Ref. ID ADHOC-D-26-02099
"Onset-Anchored Selective Computation for Resource-Constrained Vehicular Edge Networks"
(submitted as "Trustworthy Selective Computation for Resource-Constrained Vehicular Edge Networks"; retitled in this revision, see R3.7)

Response to Reviewers*

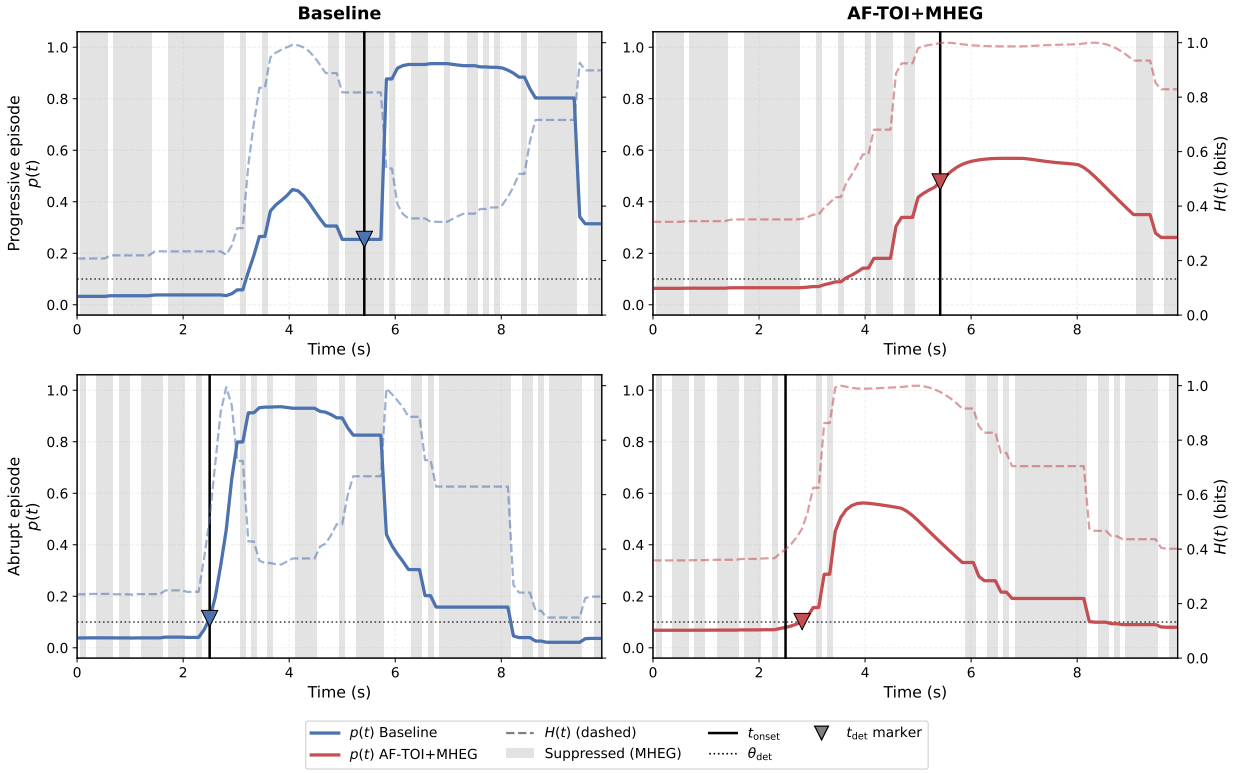
6. Comment: Frame-by-frame temporal evidence for seed 42 graph is not explained well.

Response: We agree with the reviewer. A frame-by-frame reading guide has been added to the paragraph following the first mention of Figure 5 in Section 4.2, identifying each visual element of the seed-42 examples. During revision verification we also found and corrected two problems in this figure, and we report them explicitly rather than silently: (a) the exemplar episodes of the submitted version were not selected by a stated criterion, and the abrupt exemplar was atypical (it belongs to a saturated minority of episodes whose entropy sits near the maximum throughout); the figure now uses, per regime, the episode with the *median* pre/post-onset entropy contrast among seed-42 critical episodes with central onset, and the caption states the criterion; (b) the replay that produced the suppression shading applied the entropy threshold in the wrong logarithm base (natural log instead of the base-2 entropy of Eq. 11), so the entropic branch of the gate never fired in that log; the log was regenerated with the correct base, and the entropy axes of Figures 4–6 are now uniformly in bits, matching Eq. 11. The added text reads:

(The full frame-by-frame reading guide follows the first mention of Figure 5 in Section 4.2.) Its selection criterion reads: "The exemplars are selected by a pre-declared neu-

tral criterion: within each regime, the episode whose pre/post-onset entropy contrast is the *median* among the critical episodes of seed 42 with a centrally located onset (progressive: episode 36, t_0=5.42 s; abrupt: episode 148, t_0=2.50 s)." The guide also states that detection markers of single exemplars do not arbitrate latency (aggregate latencies are settled by Table 8) and that a minority of abrupt critical episodes (12 of 48 in seed 42) runs near maximal entropy throughout. The regenerated figure is reproduced below.

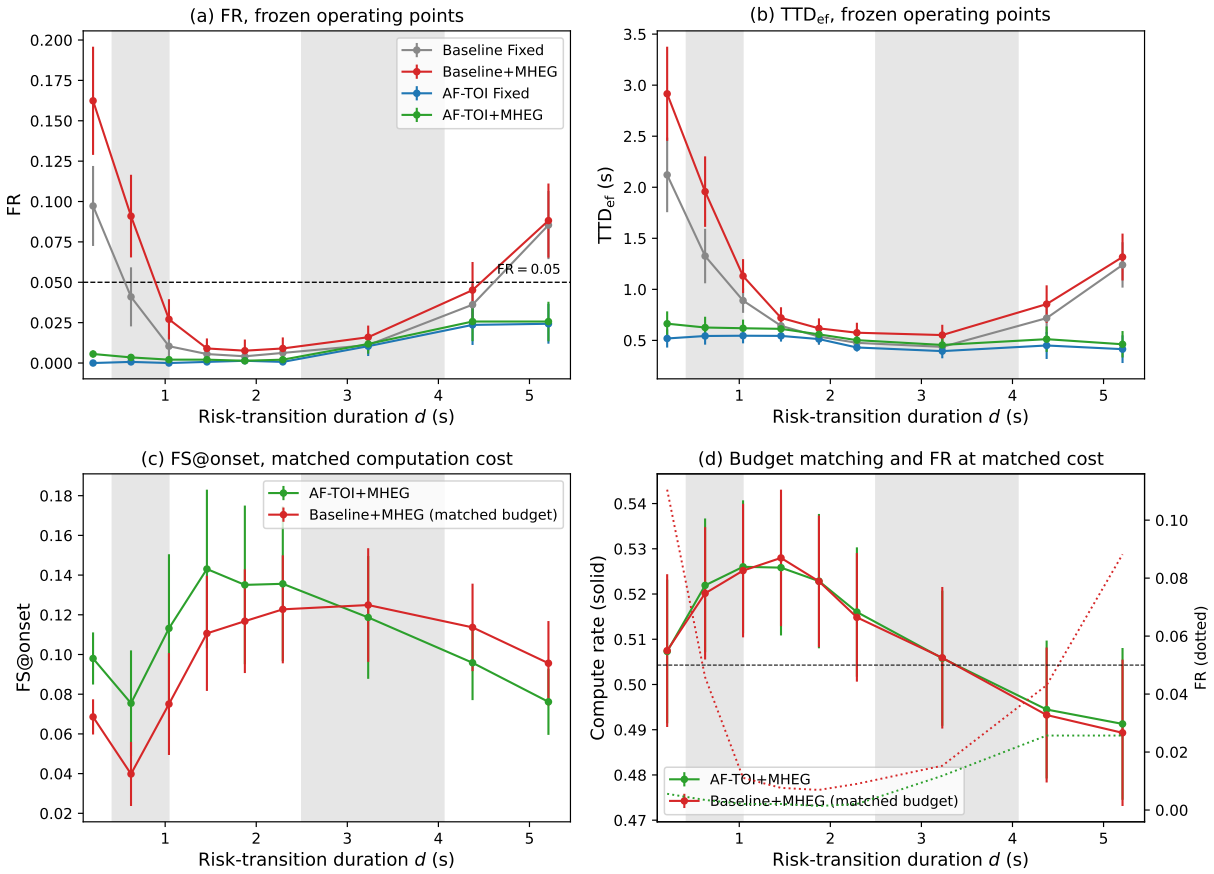
4. Comment: A central claim of the study is that temporal organization of uncertainty is important for safe selective computation, but the current experiments appear to be strongly tied to the risk-transition patterns defined by the experimental setup. The authors should investigate whether AF-TOI generalizes to unseen temporal risk trajectories, different onset durations, abrupt versus gradual transitions, intermediate-risk conditions, changes in the distribution of input features, or distribution shifts between training and testing conditions.

Response: We agree with the reviewer. To address the question of generalization across different transition durations, a new temporal-scale experiment has been added in Section 4.12, together with Figure 14 and Table 21. The experiment varies the risk-transition duration independently through a shape-preserving temporal warp while keeping t_0, the normalized transition shape, the episode context, the model weights, and the scheduler thresholds fixed. The limitations paragraph of Section 5 was also revised to distinguish this controlled temporal train–test shift from broader naturalistic distribution shift. The six aspects raised in the comment are addressed as follows.

(ii) *Different onset/transition durations* are evaluated by the new experiment of Section 4.12, across nine durations from 0.21 to 5.21 s, including interpolation and extrapolation outside the training support.

"Figure 14a–b and Table 21 report the frozen operating points. AF-TOI maintains mean FR below 0.05 at every evaluated duration (maximum duration-wise mean 0.026), and $\mathrm{TTD}_{\mathrm{ef}}$ stays within approximately 0.40–0.66 s. The Baseline crosses mean FR = 0.05 at both extrapolation extremes (mean FR 0.097 at 0.21 s and 0.085 at 5.21 s for the fixed policy), and its $\mathrm{TTD}_{\mathrm{ef}}$ follows a U-shaped profile that reaches 2.12 s at the fast extreme. At the level of individual seed×duration cells, AF-TOI exceeds FR = 0.05 in 7 of 108 cells (all at $d \geq 3.23$ s, maximum 0.108), against 22 of 108 for the fixed Baseline (maximum 0.250) and 32 of 108 for Baseline+MHEG (maximum 0.333). Frame-level F1 remained seed-sensitive under the warp, a pattern consistent with checkpoint-level variability rather than with an effect of the warp itself. Accordingly, the result is restricted to aggregate coverage and effective delay and does not constitute a per-seed guarantee: AF-TOI shows aggregate temporal-scale robustness across the evaluated synthetic range of unseen risk-transition durations." (Section 4.12, second paragraph)

"Because the two frozen gates suppress different fractions of frames, we added a post-hoc matched-budget diagnostic: for each seed×duration cell, the entropy threshold of Baseline+MHEG was adjusted by bisection (...) until its computation rate matched that of AF-TOI+MHEG on the same cell (all 108 cells matched within 1.9%, tolerance 2%; Figure 14d). (...) At matched computation cost, no systematic FS@onset advantage remains (...). Under Holm correction within each endpoint family, only the $\mathrm{TTD}_{\mathrm{ef}}$ difference at 0.21 s remains significant ($p = 0.031$), so these per-duration matched-cost contrasts should be read as exploratory. The matched-budget diagnostic supports a temporal-scale coverage-and-timeliness advantage, not a universal improvement in near-onset suppression placement." (Section 4.12, third paragraph)
The new figure and table are reproduced below.
